## ADDENDUM NO. 3

To: All Plan Holders of Record and Interested Parties  
Project: Clinton County Administration Building - Addition & Alterations  
Project No.: 22072  
Issue Date: March 5<sup>th</sup>, 2024  
Bids Due: 2:00 PM, March 13, 2024

GROUND FLOOR  
PIPING  
DEMOLITION  
PLAN

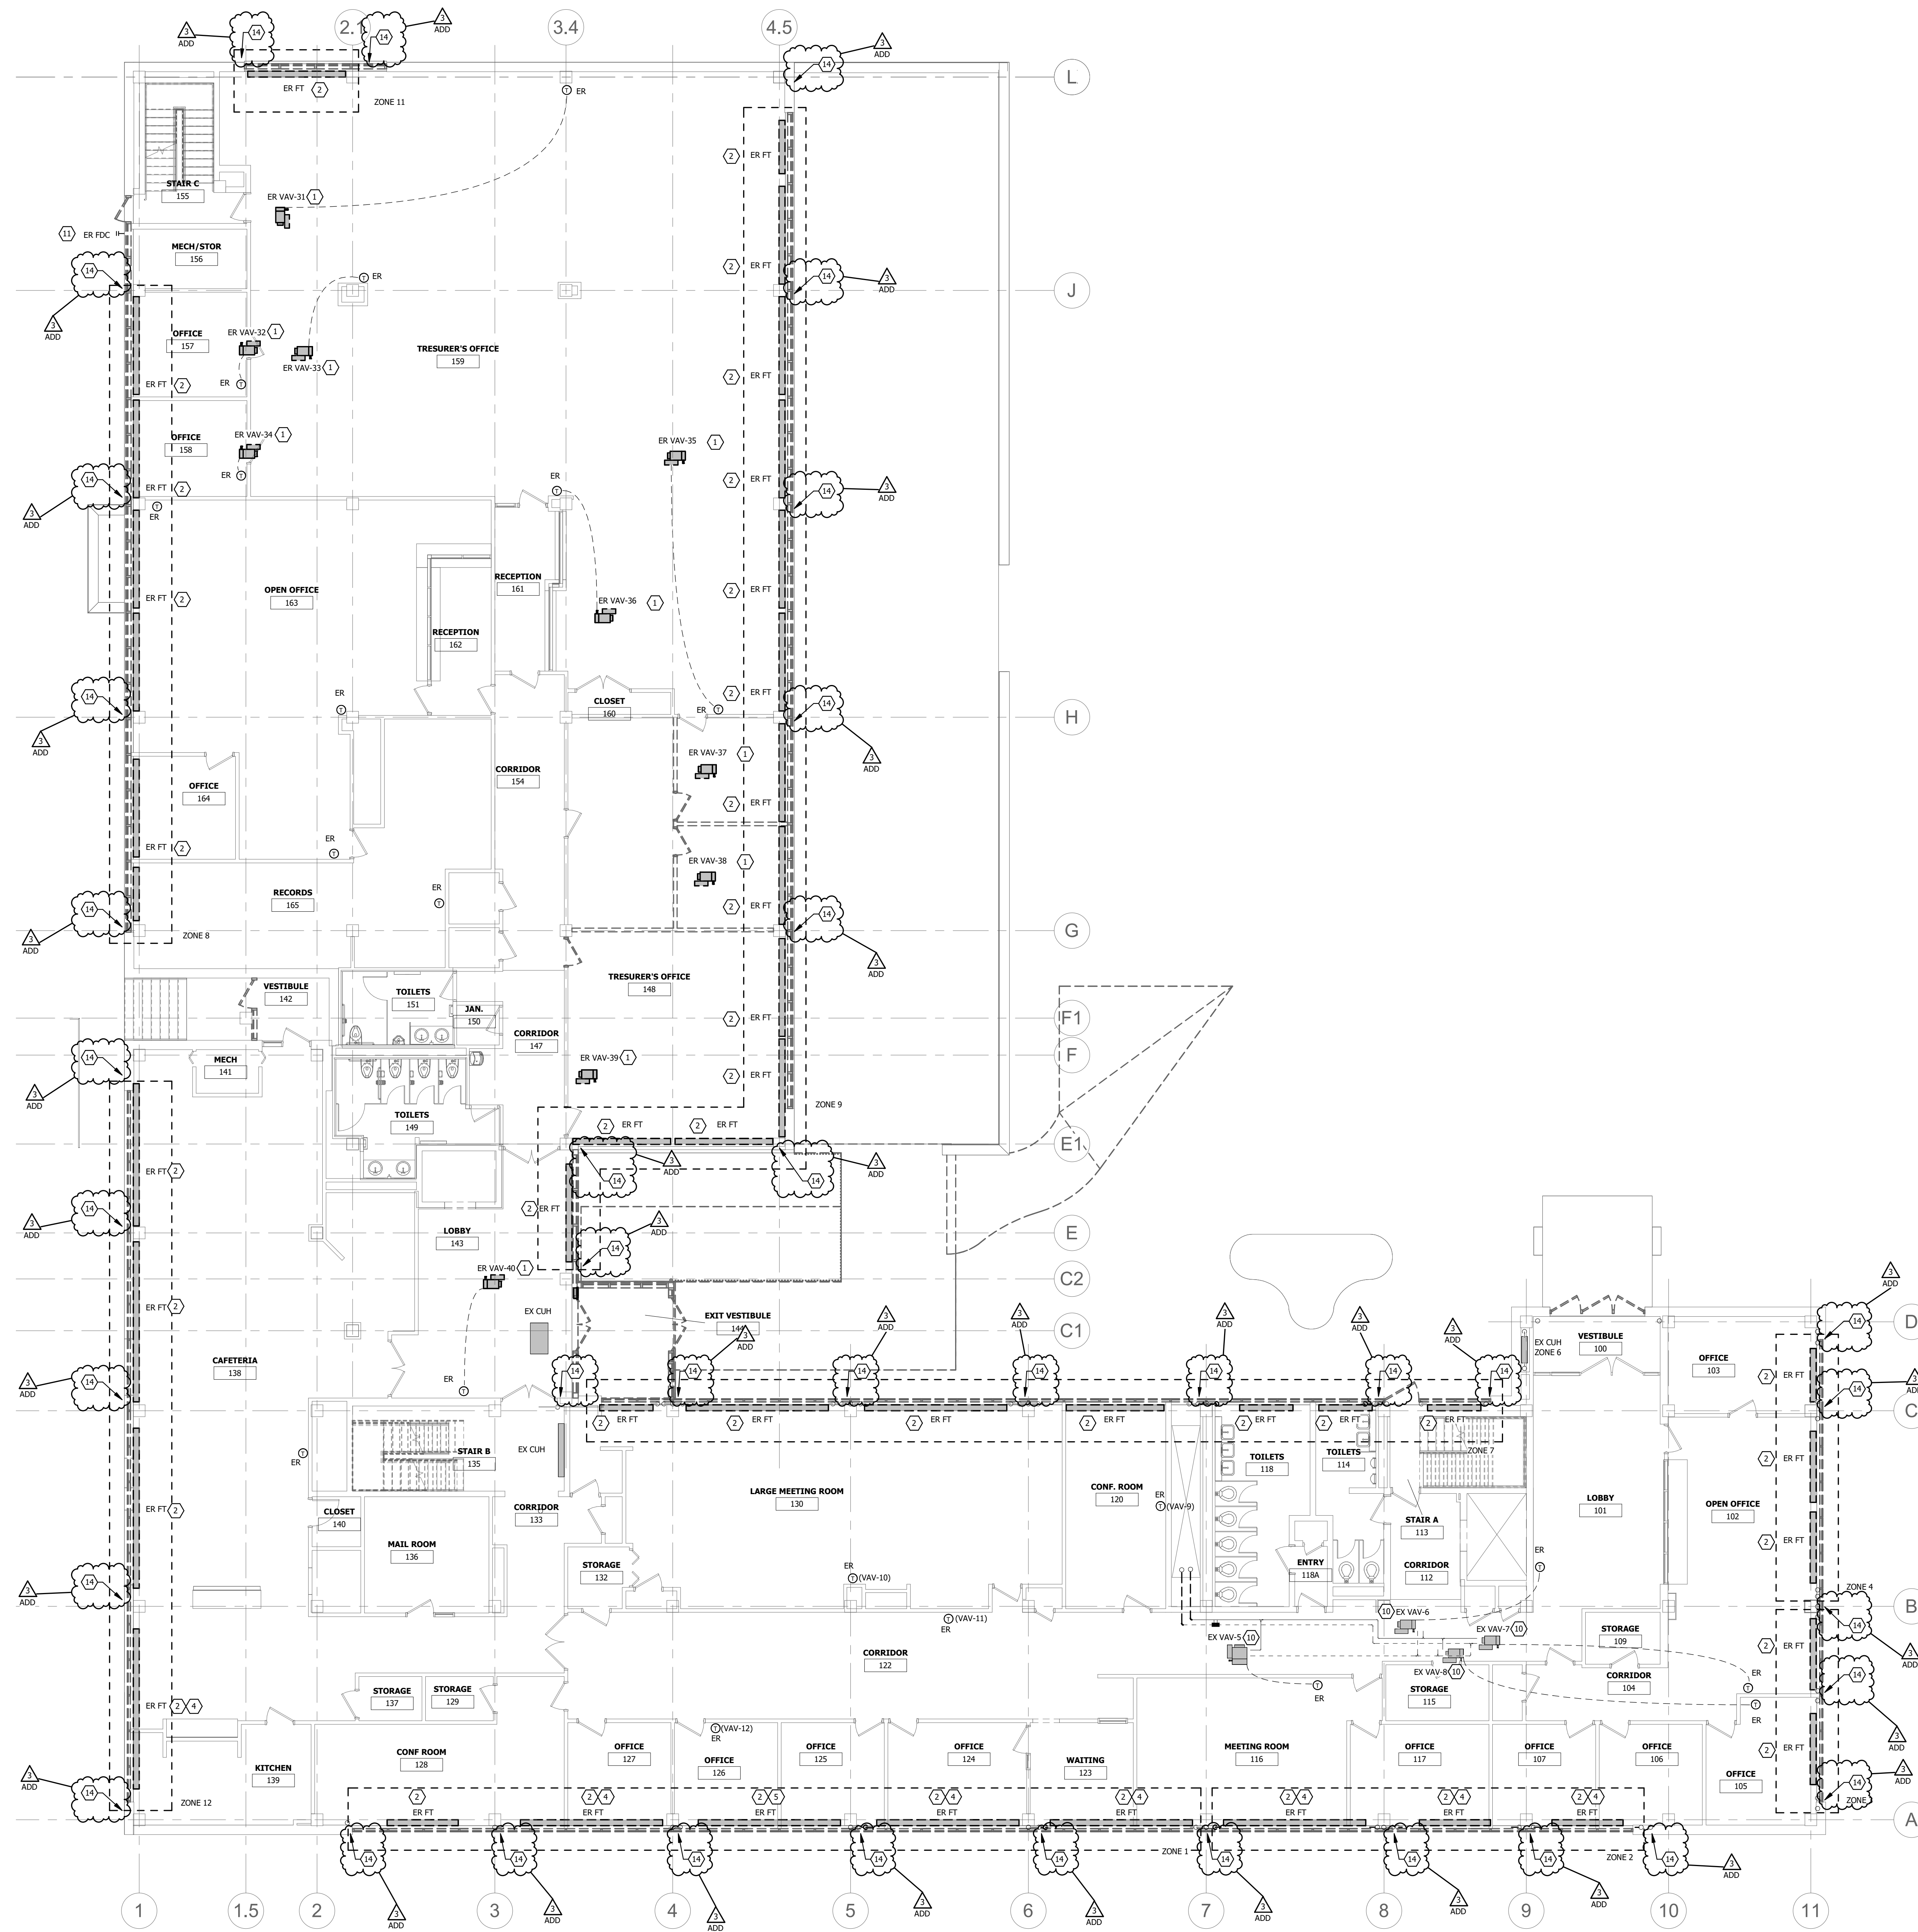
1. Demolition Referenced Notes
  - A. **ADD** Note 14 to read: "Hot water supply and return risers are to remain unaltered. Remove horizontal piping between existing riser and fin tubes. Refer to detail on sheet M501."
2. Ground Floor Mechanical Piping Demolition Plan
  - A. **ADD** Note 14 to heating water supply and return riser locations. See reissued sheet for more details.

**MD201**

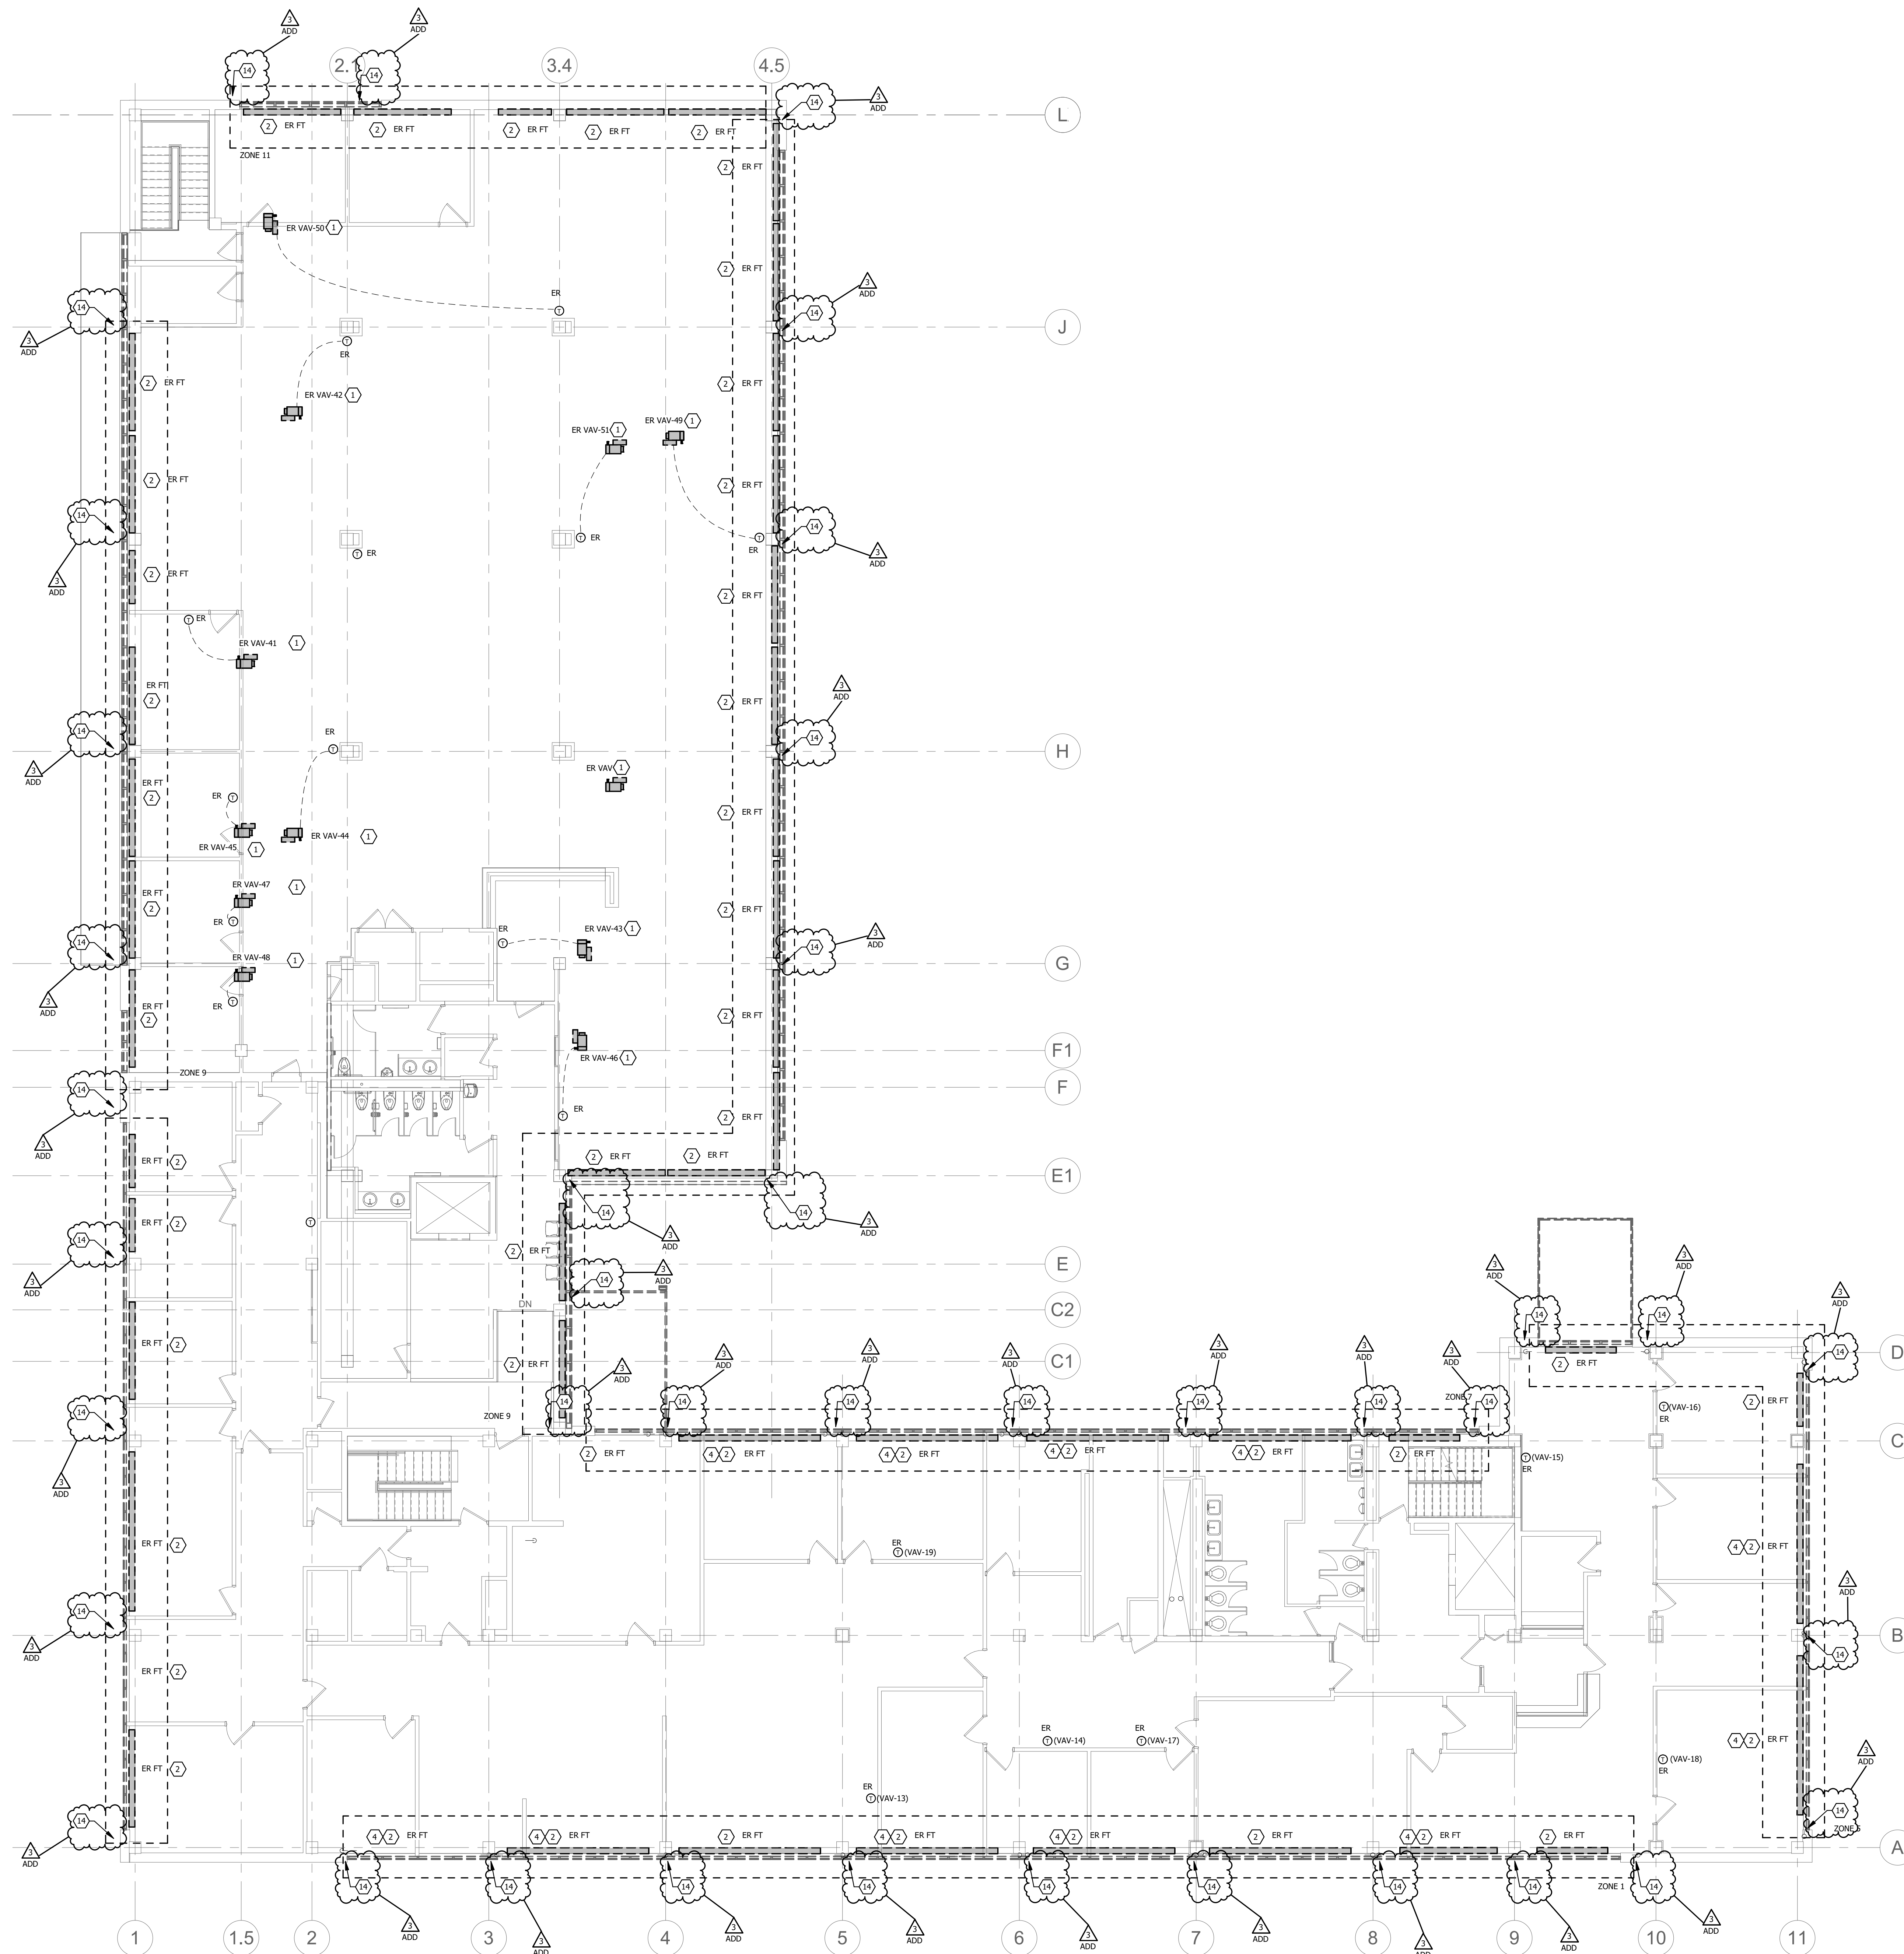
1. Demolition Referenced Notes
  - A. **ADD** Note 14 to read: "Hot water supply and return risers are to remain unaltered. Remove horizontal piping between existing riser and fin tubes. Refer to detail on sheet M501."
2. Ground Floor Mechanical Piping Demolition Plan
  - A. **ADD** Note 14 to heating water supply and return riser locations. See reissued sheet for more details.

**MD202**

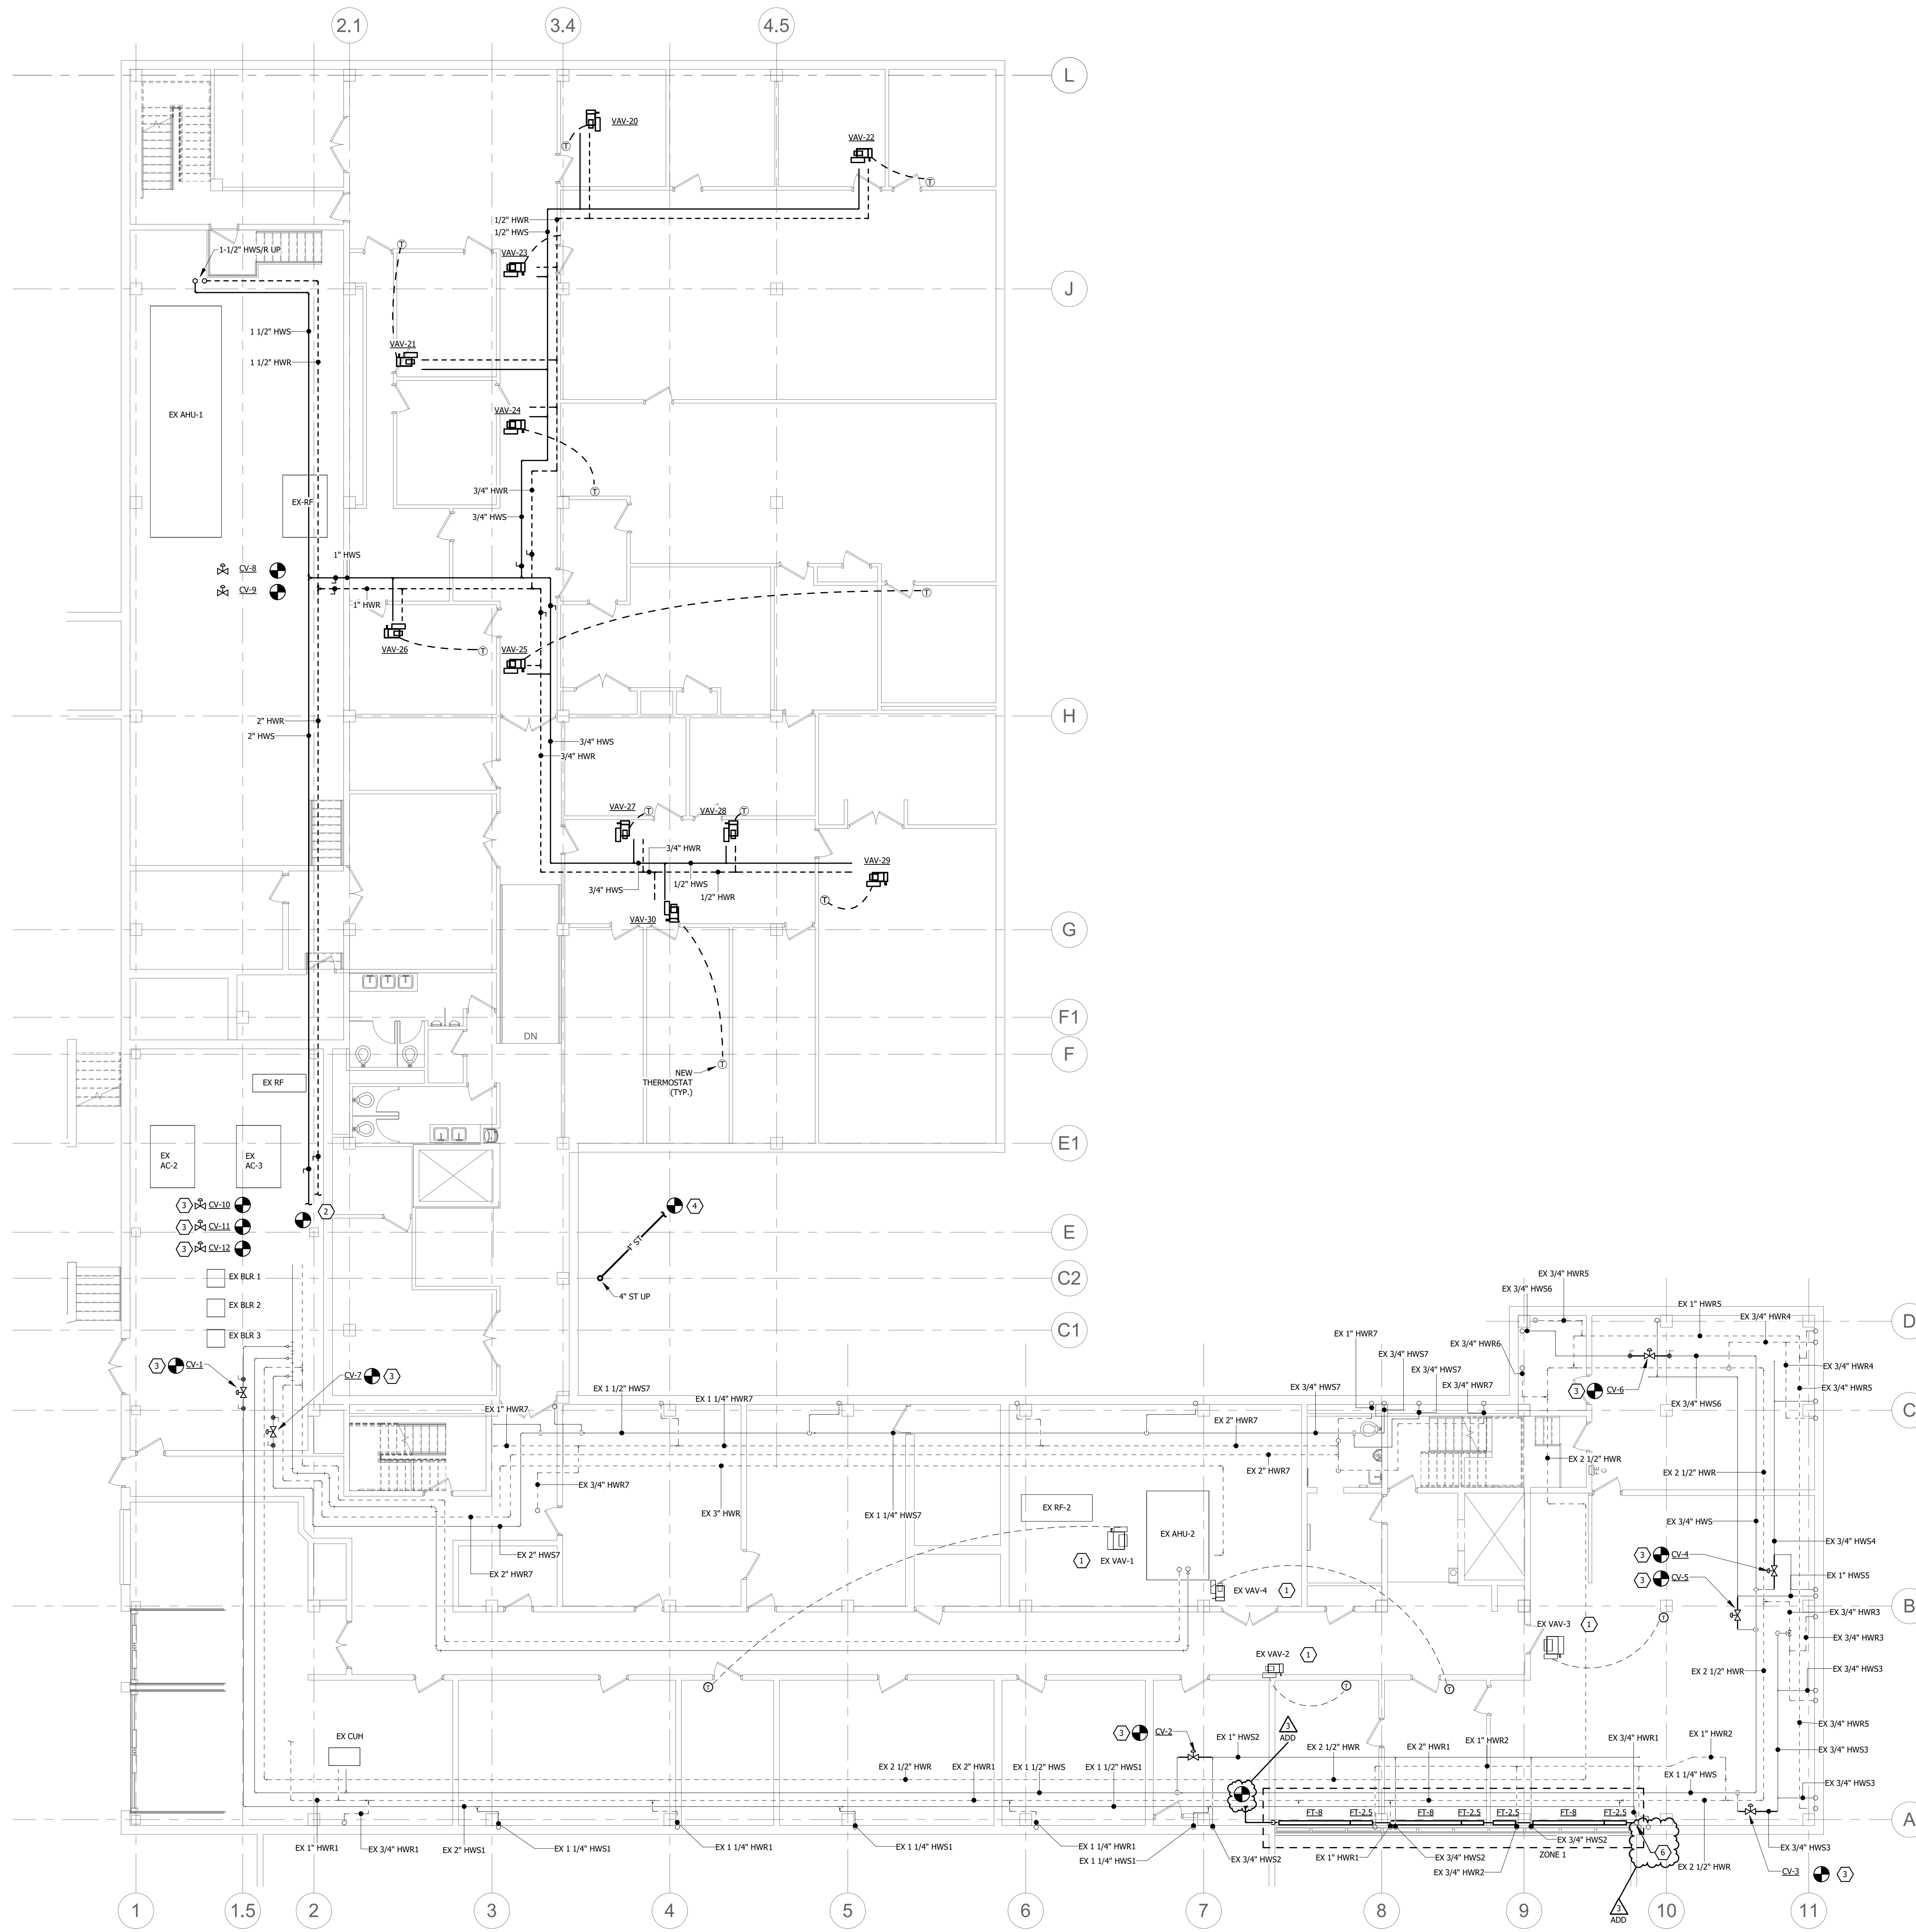
1. Demolition Referenced Notes
  - A. **ADD** Note 14 to read: "Hot water supply and return risers are to remain unaltered. Remove horizontal piping between existing riser and fin tubes. Refer to detail on sheet M501."
2. Ground Floor Mechanical Piping Demolition Plan
  - A. **ADD** Note 14 to heating water supply and return riser locations. See reissued sheet for more details.
